ADDENDUM NO. ONE

PROJECT TITLE: Multi-Purpose Meeting
Room Renovation, Peoria Zoo

ISSUANCE DATE: 4/1/13

ADDENDUM DRAWING
PARTIAL ROOF FRAMING PLAN FOR RTU LOCATION

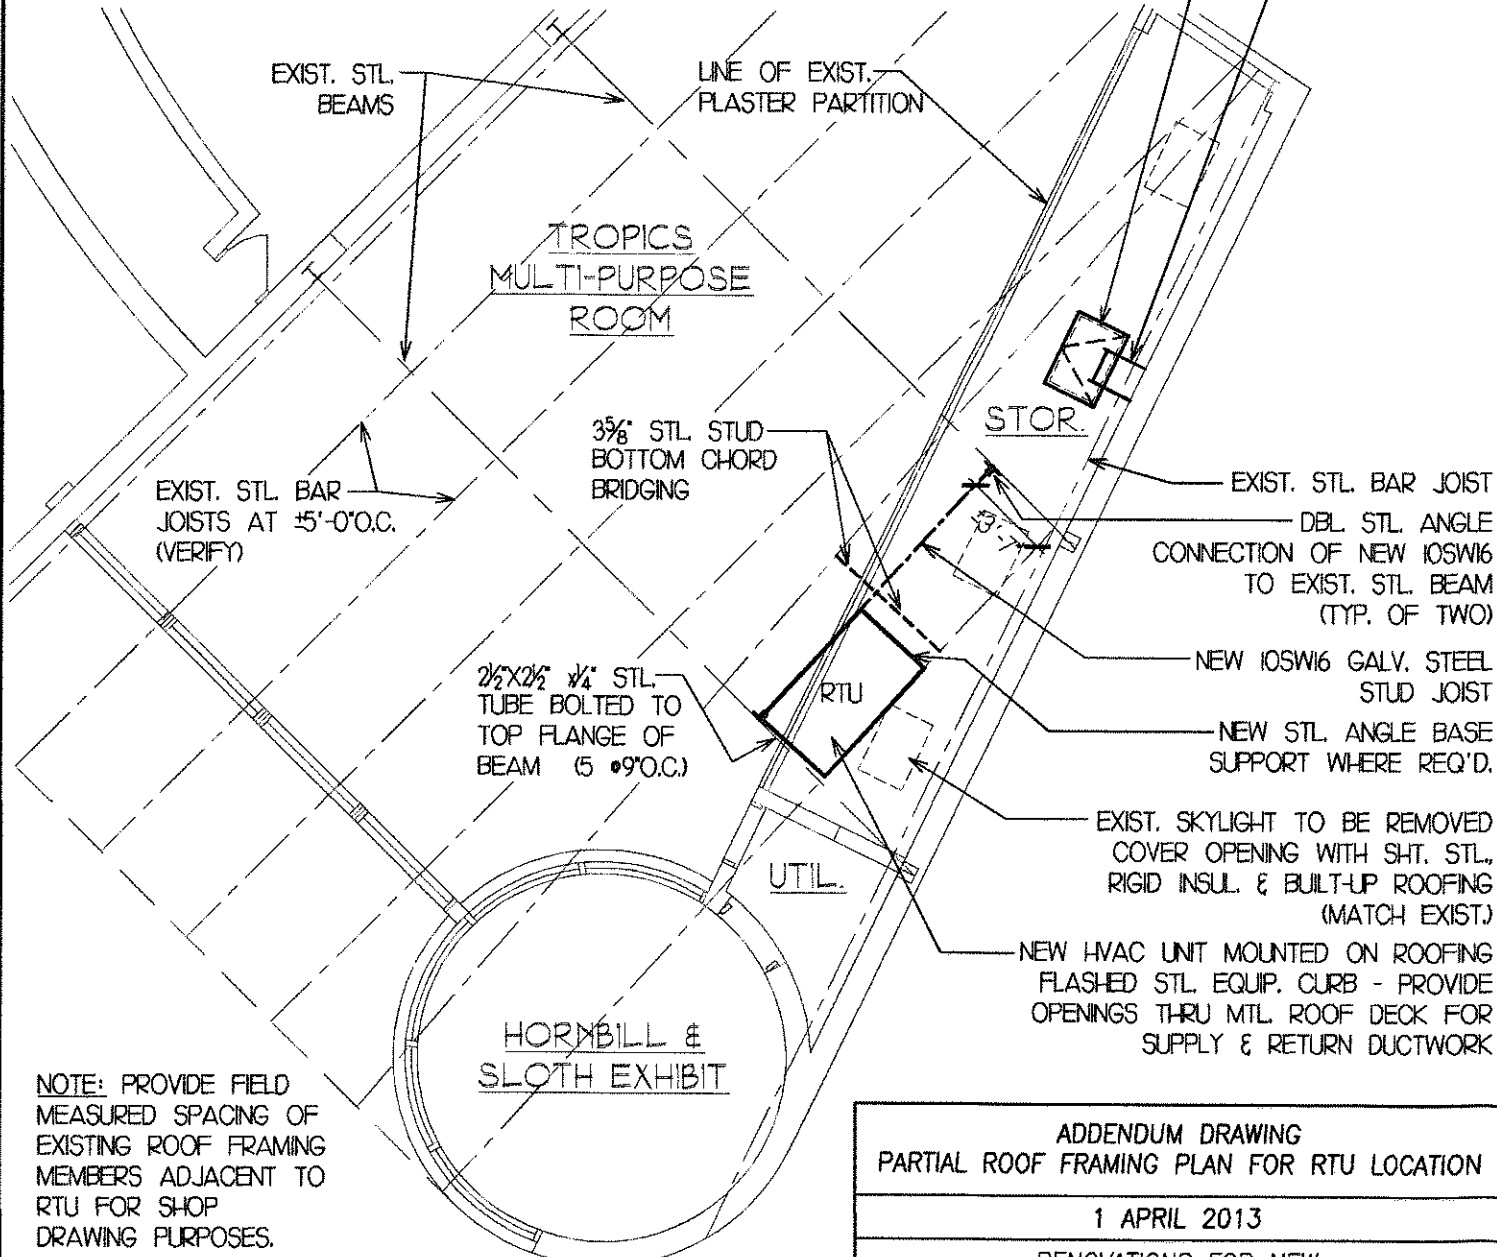
Item 14: See Attached Addendum Drawing of Partial Roof Framing Plan For RTU Location, showing RTU and associated support framing, and design requirements for new access ladder and roof hatch.

NEW SHOP FABRICATED VERTICAL TYPE STEEL LADDER W/ STL. BAR AND ANGLE SUPPORT BRACKETS AS REQ'D. AND ANCHOR STRINGER LEGS TO FLR. FOR BEARING, FIELD VERIFY HEIGHTS (±22'-0") AND SUPPORT POINTS, WALL MOUNTED STAND-OFF BRACKETS TO EXTEND OUTWARD TO CLEAR EXISTING ROOF JOIST. LADDER SHALL MEET OSHA STANDARDS 1910.27 FOR FIXED LADDERS, INCLUDING CODE CONFORMING LIVE LOAD DESIGN WEIGHTING. LADDER TO BE 18" WIDE WITH STRINGERS A MINIMUM OF 2½"x½" BAR STOCK AND ¾" ROUND STEEL RUNGS.

REMOVE EXIST. SKYLIGHT & ENLARGE OPENING, INCLUDING PROVISION FOR SUPPLEMENTAL STL. ANGLE FRAMING TO ACCOMMODATE NEW 30"x36" ROOF-FLASHED CURB MOUNTED CORROSION RESISTANT GALV. STL. BONDERIZED POWDER-COATED FINISH ROOF HATCH ASSEMBLY (BY BARCOCK-DAVIS, BILCO, GLOBAL OR NYSTROM). CURB AND LID TO HAVE RIGID INSUL WITH PERIMETER GASKET SEAL ON LID. CURB TO HAVE BASE FLANGE & ROOF CNTRFLSH'G. LEG AT TOP PERIMETER. OPERATION TO BE CAM TYPE TURN HANDLE LATCH WITH ENCLOSED STL. COMPRESSION SPRINGS CONTROLLING CONTINUOUS HINGED LID. INCLUDE STANDARD FIXED OSHA CONFORMING GUARDRAILING COMPONENT WITH REMOVABLE FORWARD SECTION.

NOTE: PROVIDE FIELD MEASURED SPACING OF EXISTING ROOF FRAMING MEMBERS ADJACENT TO RTU FOR SHOP DRAWING PURPOSES.
